AMERICAN LANDMARK CORPORATION
SMITHMOORE ADDITION
DRAINAGE DETAILS

JOB NO. 423
PLAN D
SHEET 1 of 4

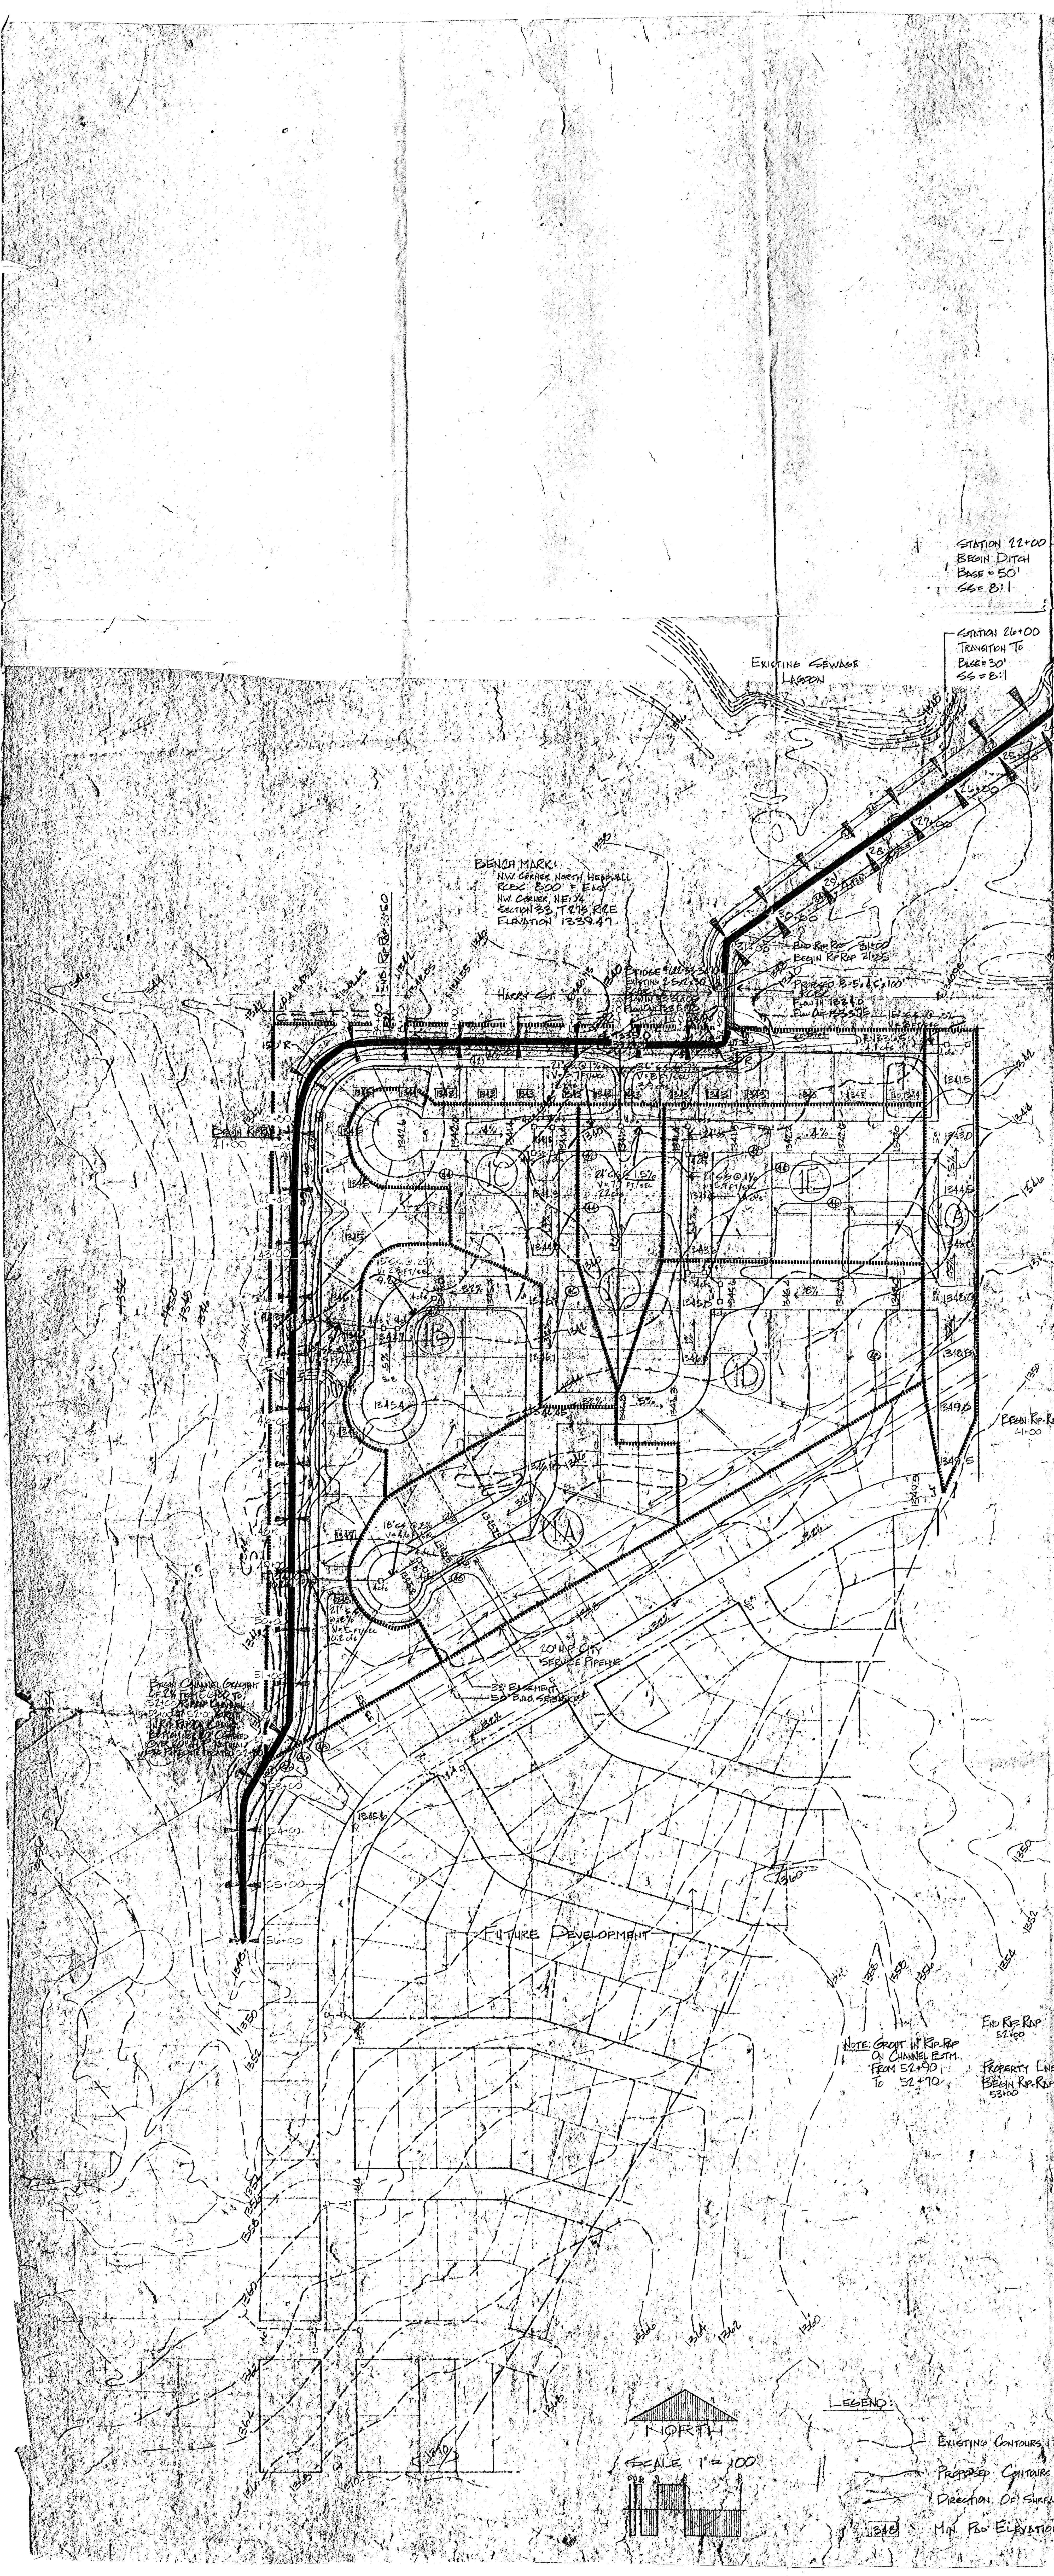
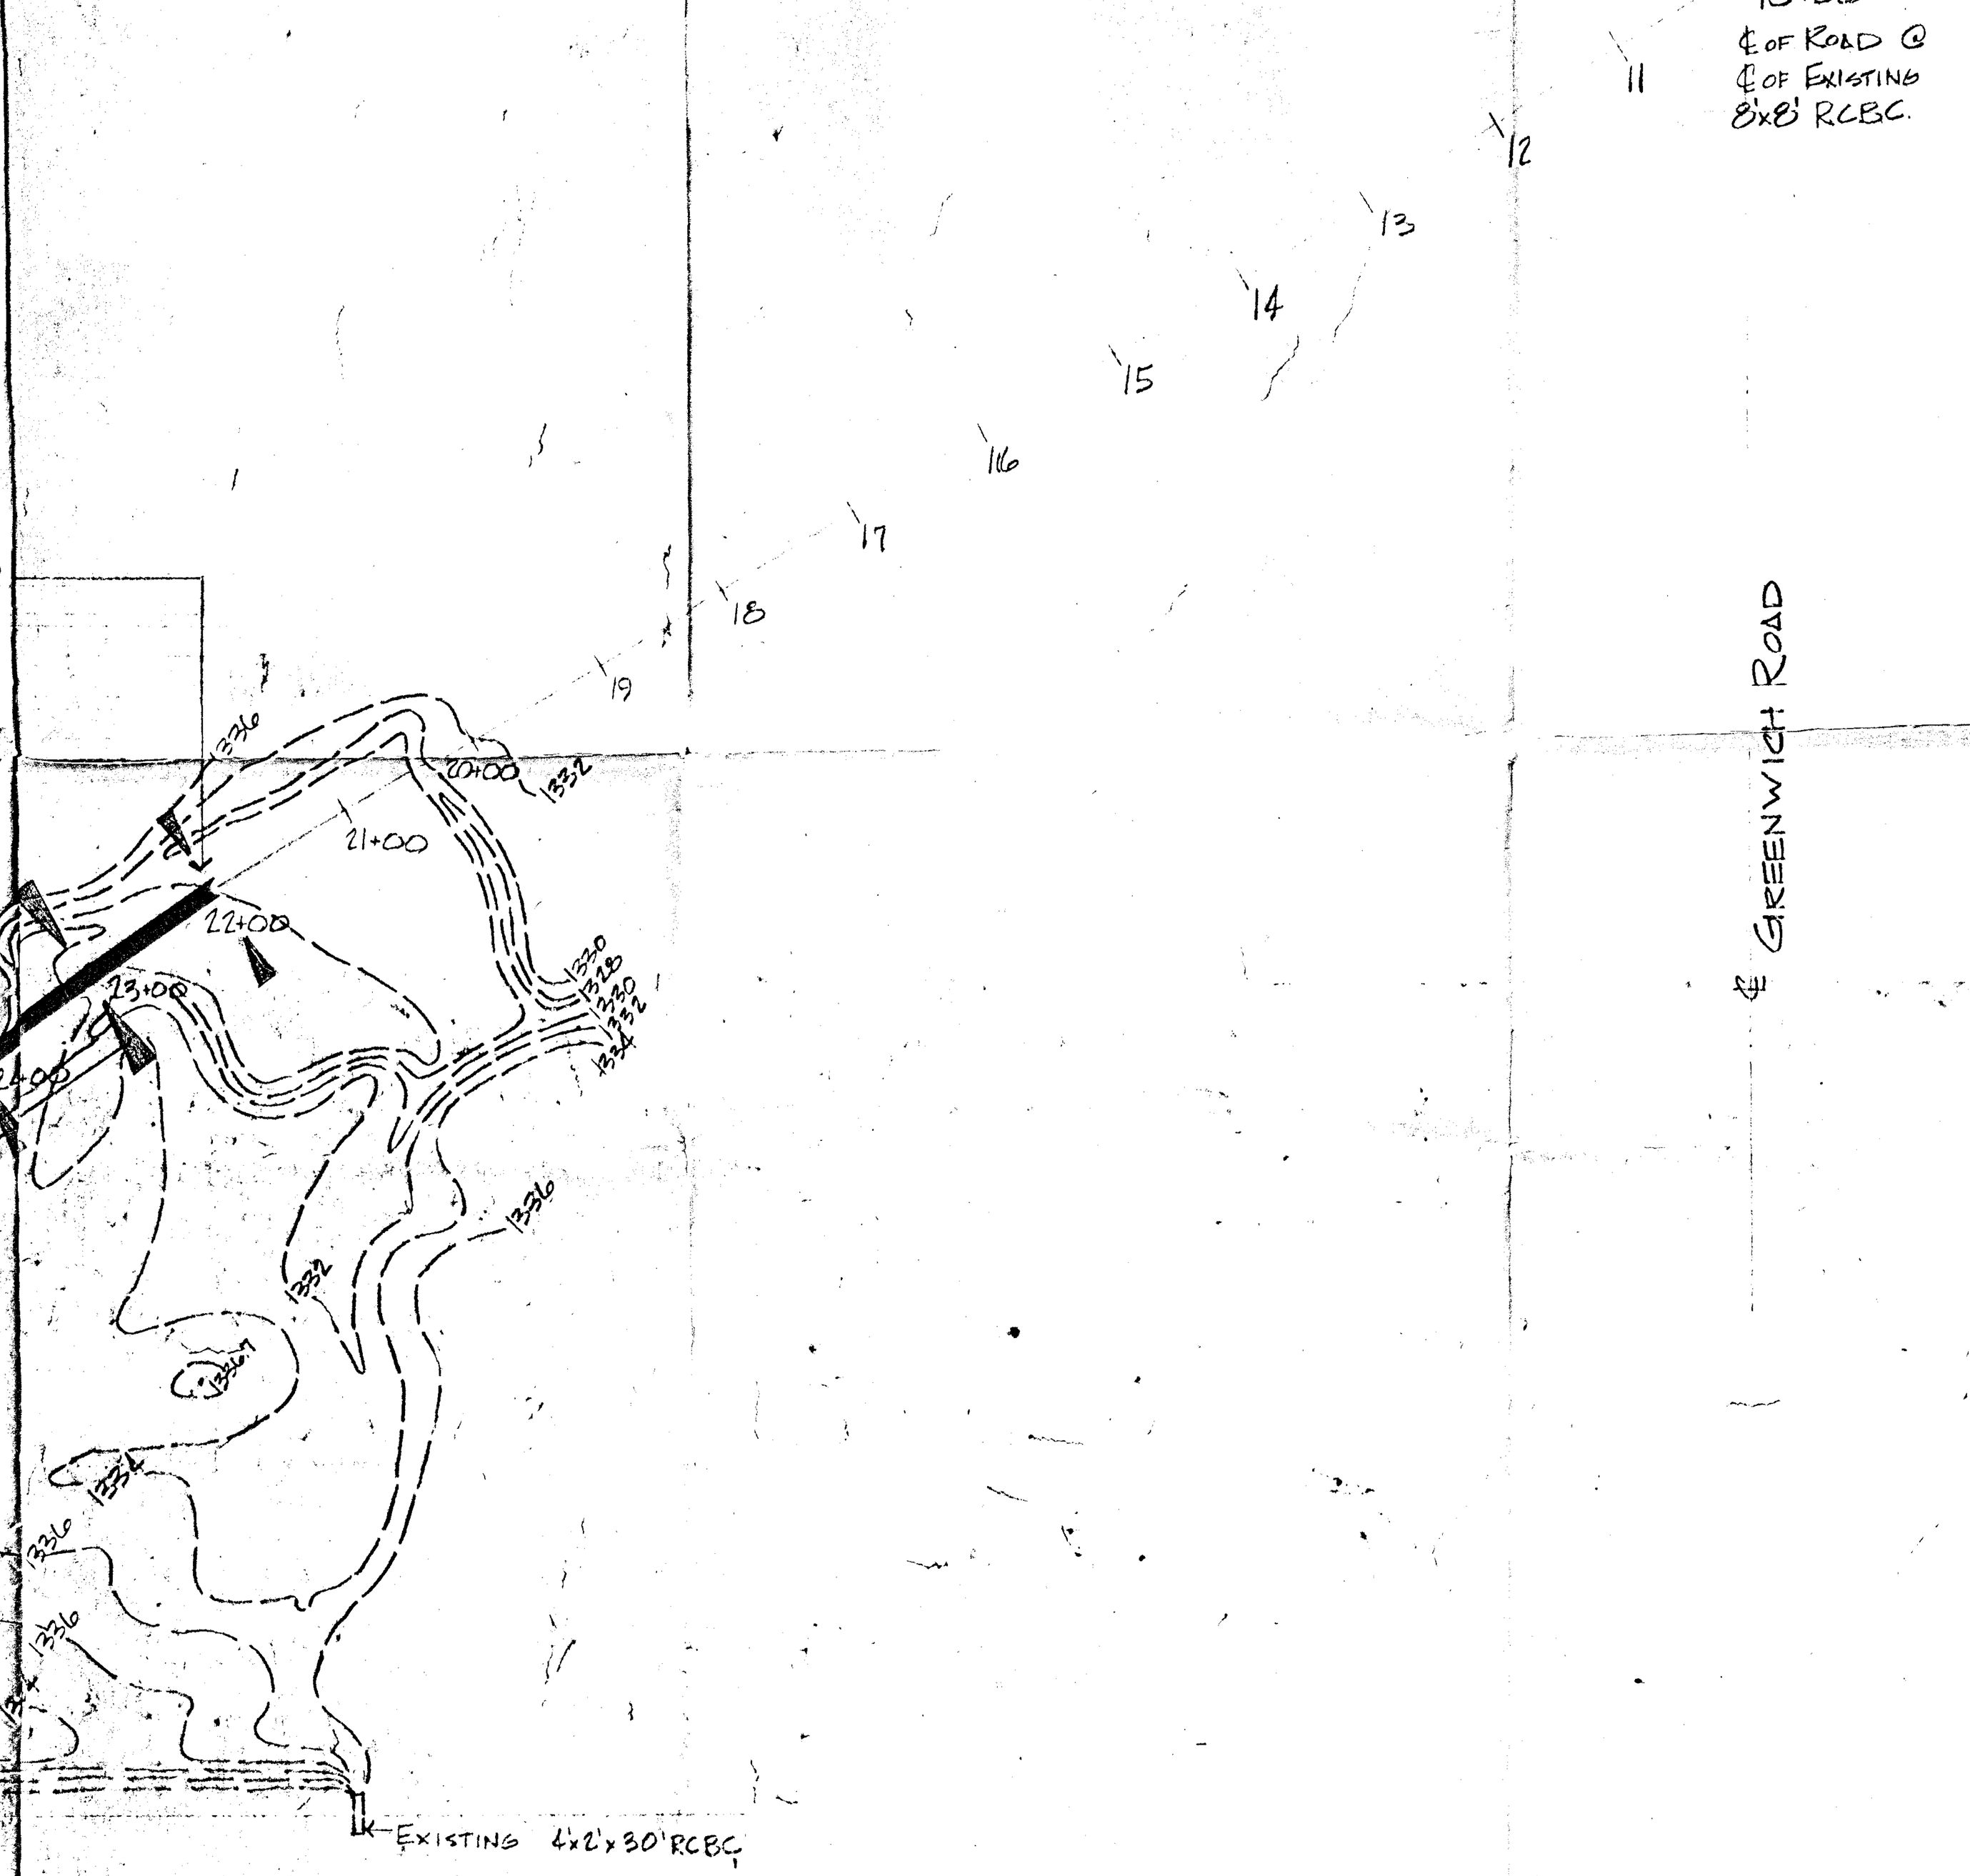
1. A minimum Tc of 15 min can be used to calculate runoff.
2. Suggest to add one inlet across the St. in Parcel 1G
3. Suggest to size pipe to handle 100 yr flow for the stretch between lots, so that no swale is required.
4. Is there appropriate drainage dedication north of Harry?
5. North line does not have enough gradience for the slope specified.
